Contractor:	Tradition Construction Inc.	Date:	October 1, 2024
Reason for Change:	Owner Request	Project Name:	Coldstream Municipal Office Addition and Renovation
		Project No.:	RFT-CMS-2023-01; +VG #22281

1. To remove existing wall tile and patch & repair walls as required to receive new finishes as per enclosed drawing AR-47 & AR-52. Provide laminated gypsum board & tile backer board at existing block walls as per enclosed drawing AR-47.

CONTEMPLATED CHANGE ORDER

1.1 CCO-ME-14 Washrooms 168 & 169 Refresh

1 PARTIAL FLOOR PLAN
 AR-47
 0 500 1000 2500mm

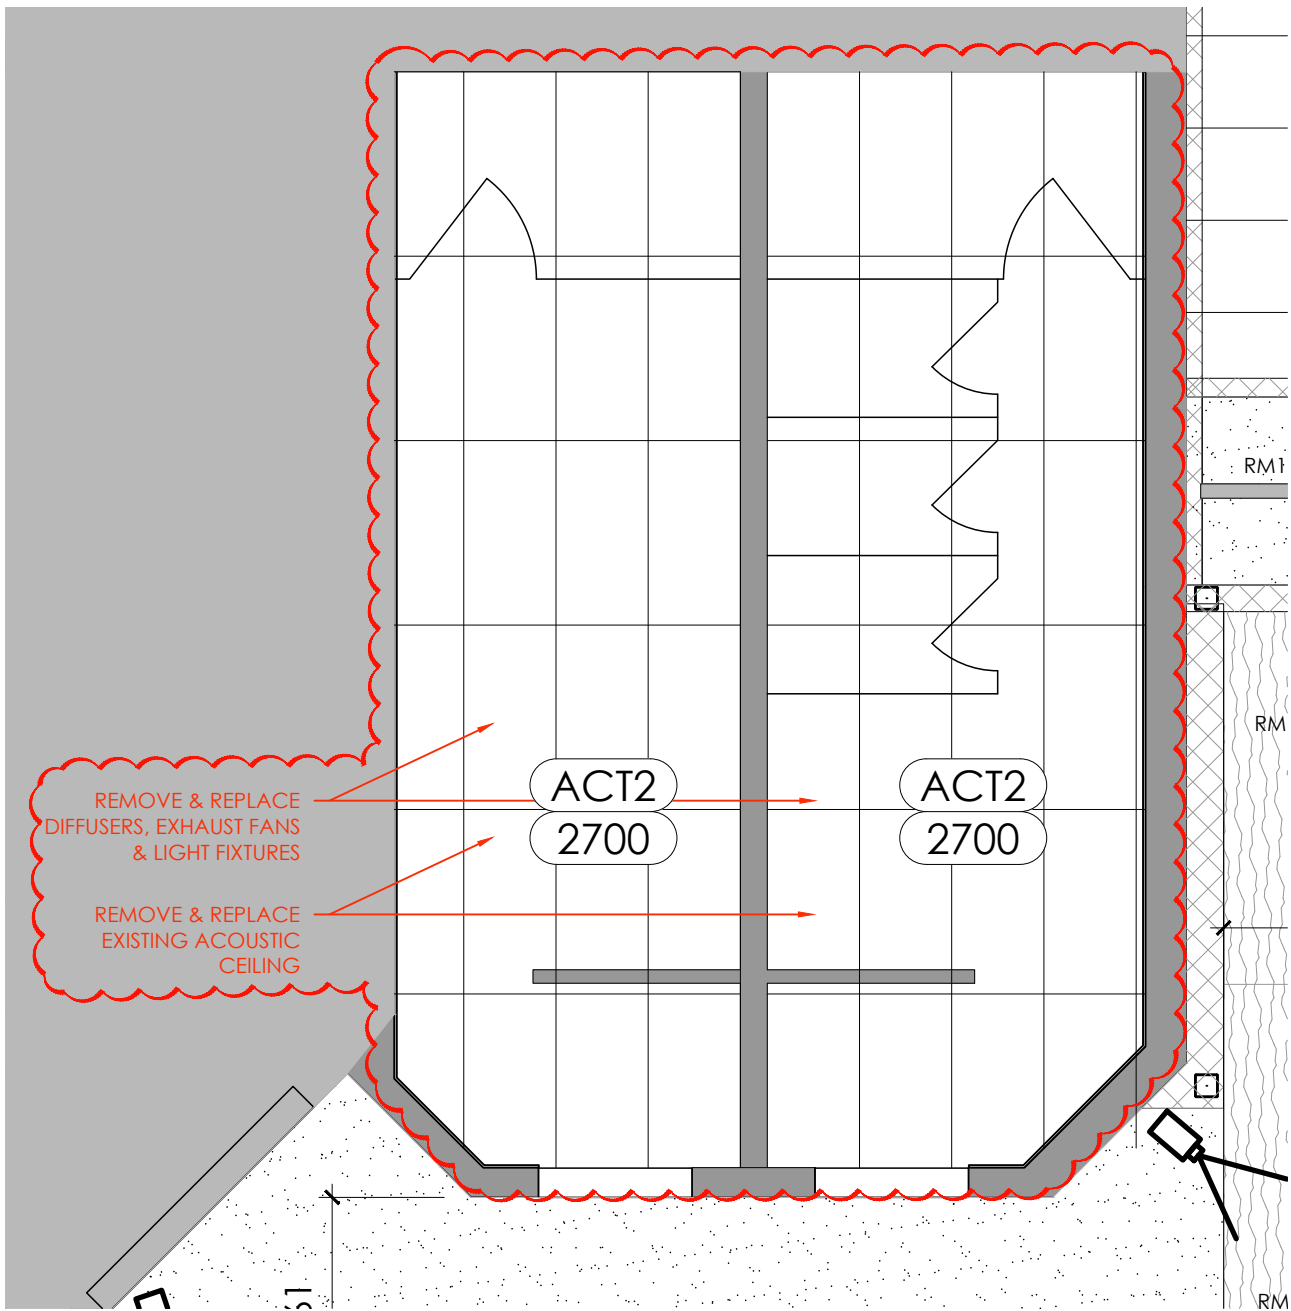
2. To remove existing floor finish & make good existing subfloor to receive new floor finish as per enclosed drawing AR-47 & AR-51.
3. To remove and replace existing washroom partitions as per enclosed drawing AR-47. New washroom partitions to be Hadrian Phenolic Elite Max Series, 92" in 317 Field Elm.

6. To paint existing door & frame as per enclosed drawing AR-47.
7. To provide solid surface countertop with P.Lam gables as per enclosed drawings AR-49 & AR-50.

1 PARTIAL REFLECTED CEILING PLAN
AR-48

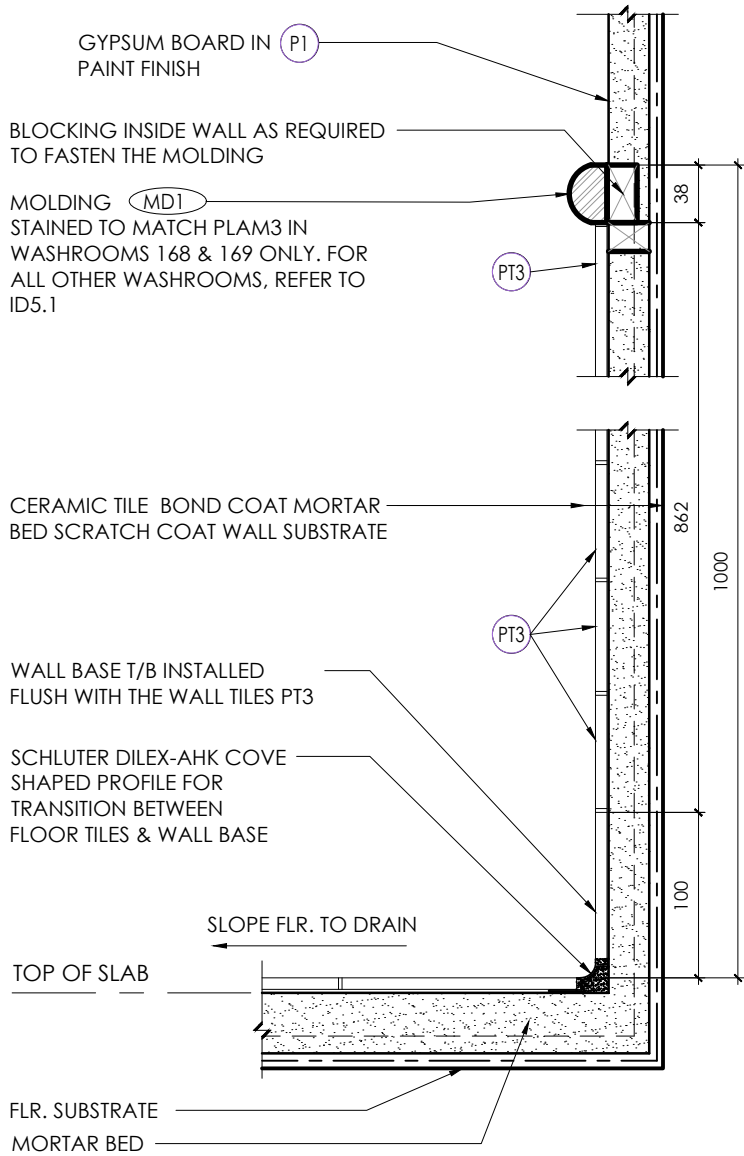
4. To remove existing acoustic ceiling and install new acoustic ceiling grid & tiles as per enclosed drawing AR-48.
5. To remove existing washroom accessories & turn over to owner.

1 GROUND FLOOR PLAN - PLUMBING NEW
M2.1 SCALE: 1:100

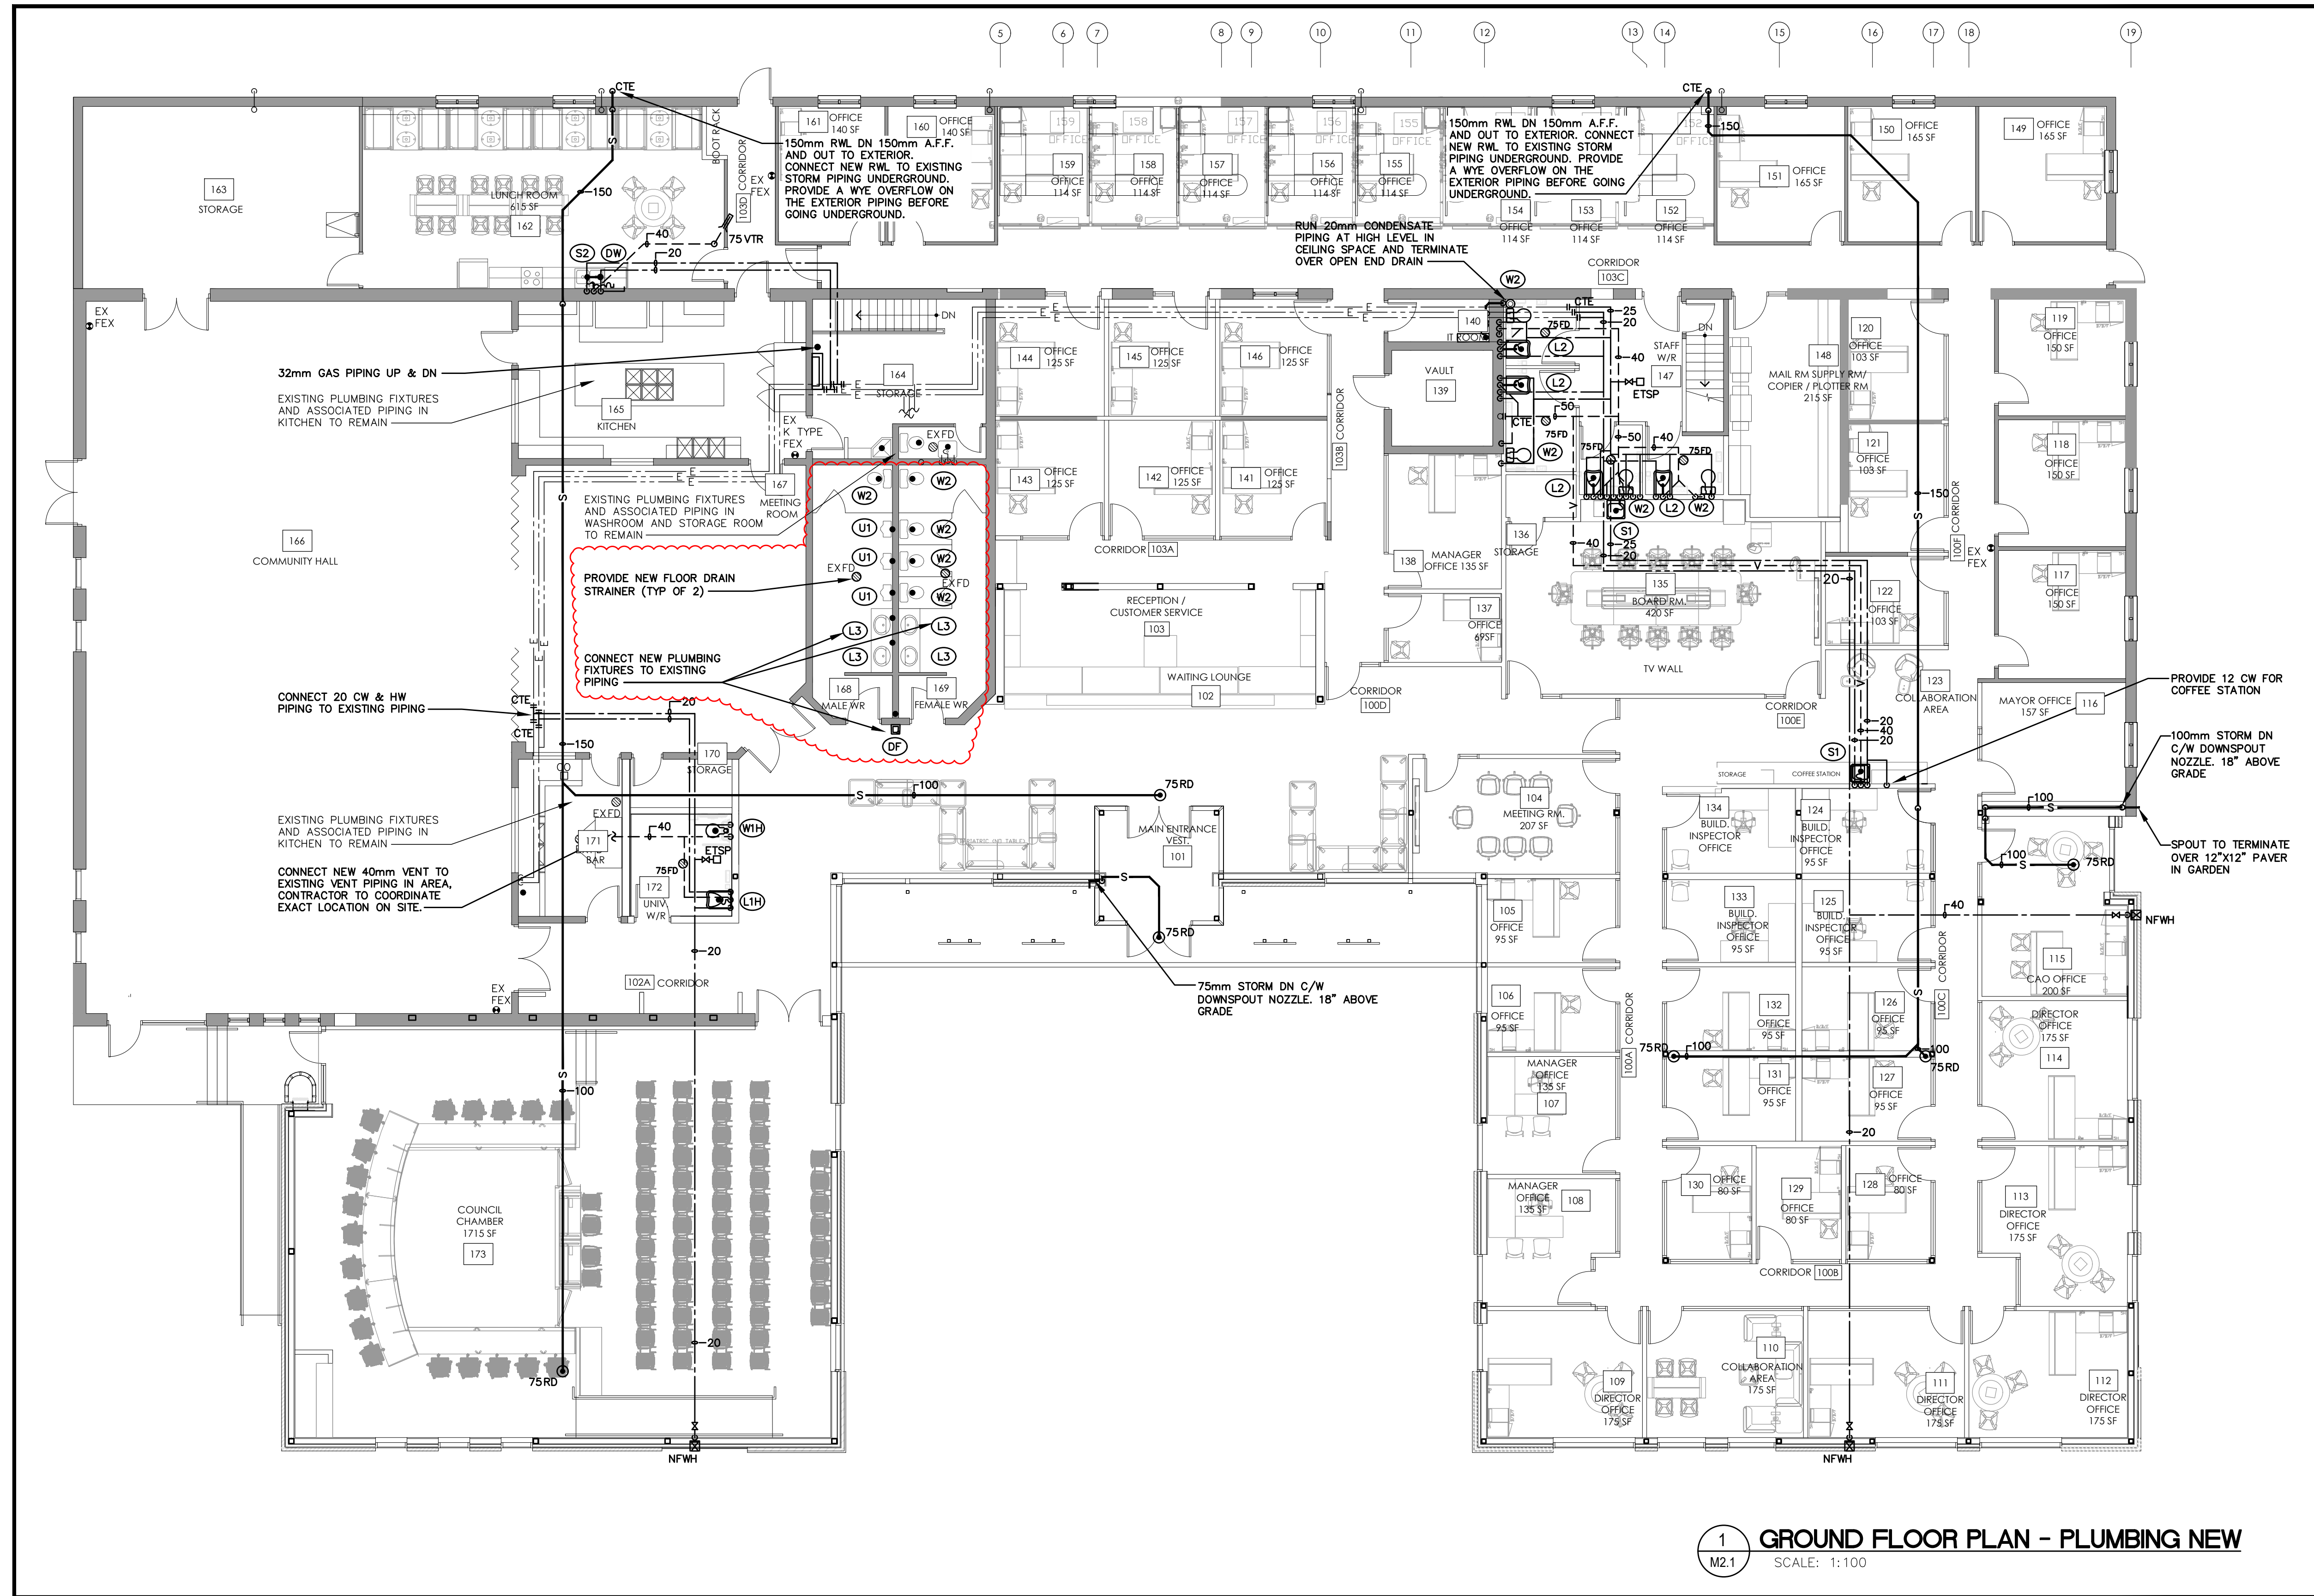
- .3 Remove floor drain strainers.
- 3.2 Refer to Drawing *M2.1 Ground Floor Plan – Plumbing New*
- .1 Refer to revised drawing M2.1.5 included herewith.

- .2 Add new water closets (W2).
 - .3 Add new urinal (U1).
 - 1. Bowl: American standard Maybrook 6581.001.
 - 2. Flush Valve: Delta Commercial 81T201.
 - 3. Carrier: reuse existing if possible.

- .4 Add new Drinking Fountain (DF).
 - 1. Fountain: Elkay VRCDMWSK c/w manufactures wall carrier.
 - 2. Supplies: McGuire #HST11LK.
 - .5 Add new floor drain strainer, match existing manufacture.

1 GROUND FLOOR PLAN - HVAC - DEMOLITION
SCALE: 1:100

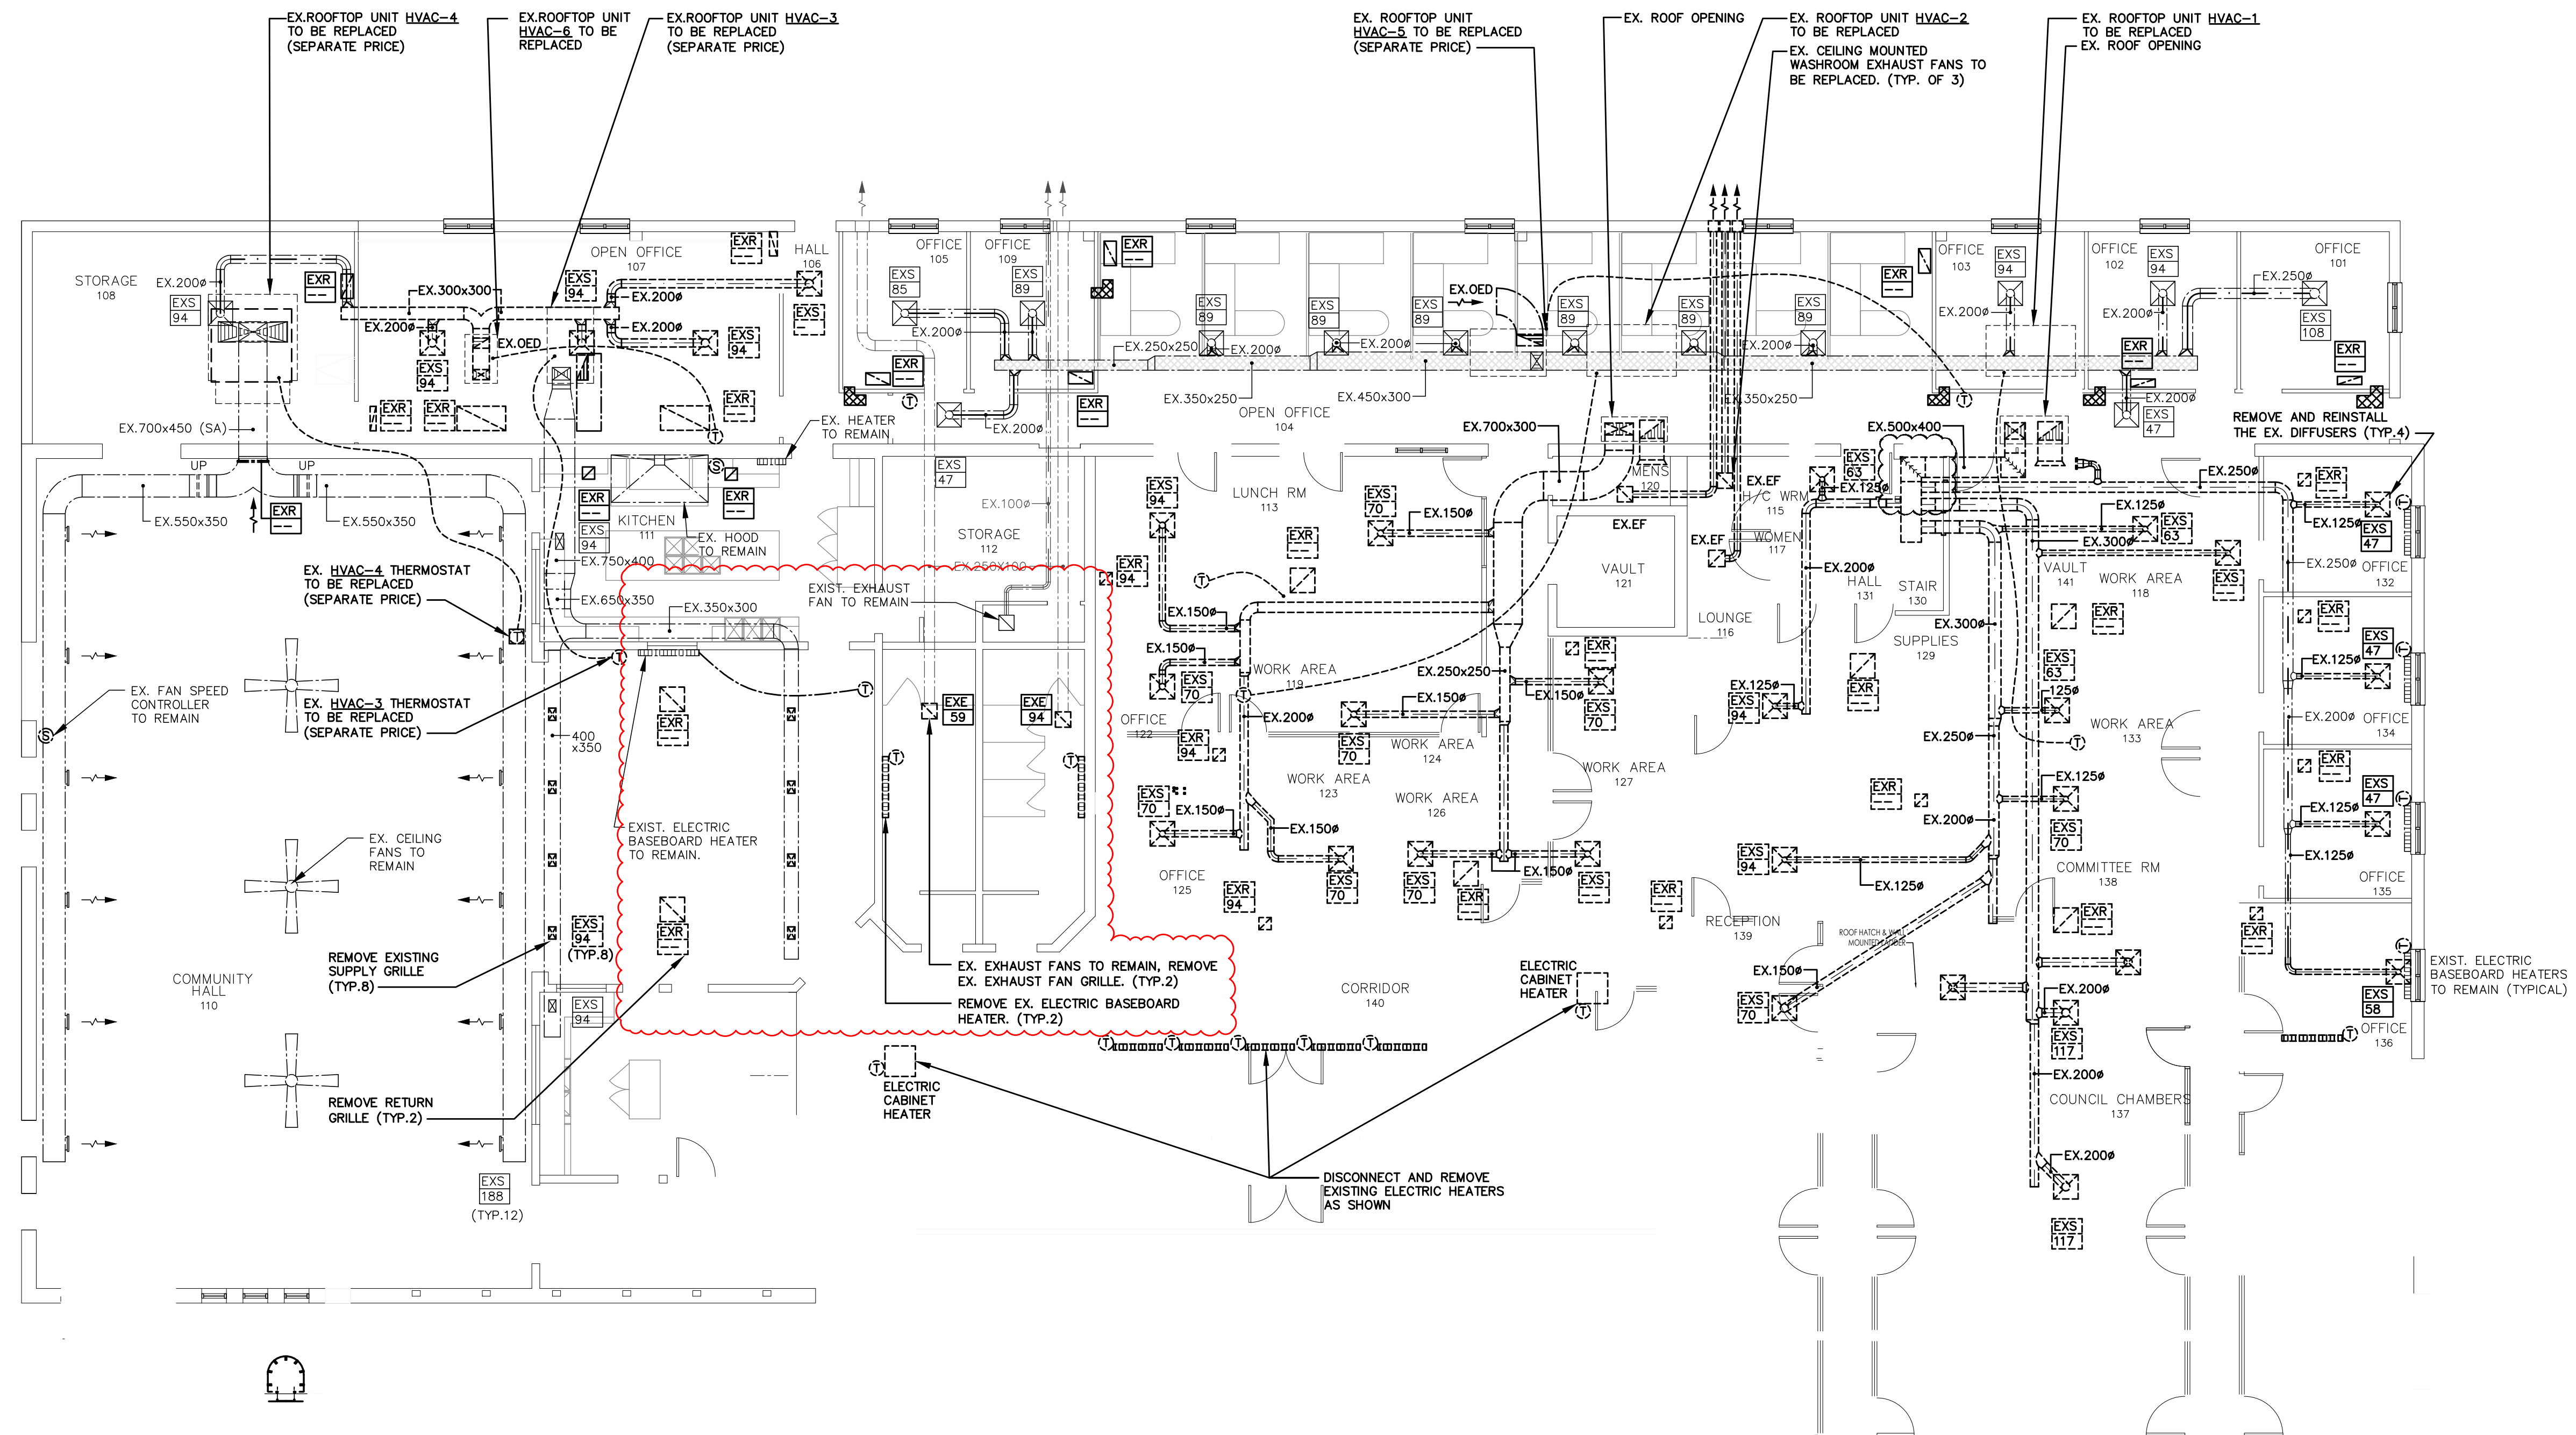
- 3.3 Refer to Drawing *M3.0 Ground Plan and Roof Plan – HVAC Demolition*
- .1 Refer to revised drawing M3.0.2 included herewith.
 - .2 Remove the existing exhaust grille of the existing exhaust fan in the 168 WR and 169 WR.

- .3 Remove the existing electrical baseboard in the 168 WR and 169 WR.
- 3.4 Refer to Drawing *M4.0 Ground Floor Plan – HVAC New*
- .1 Refer to revised drawing M4.0.7 included herewith.
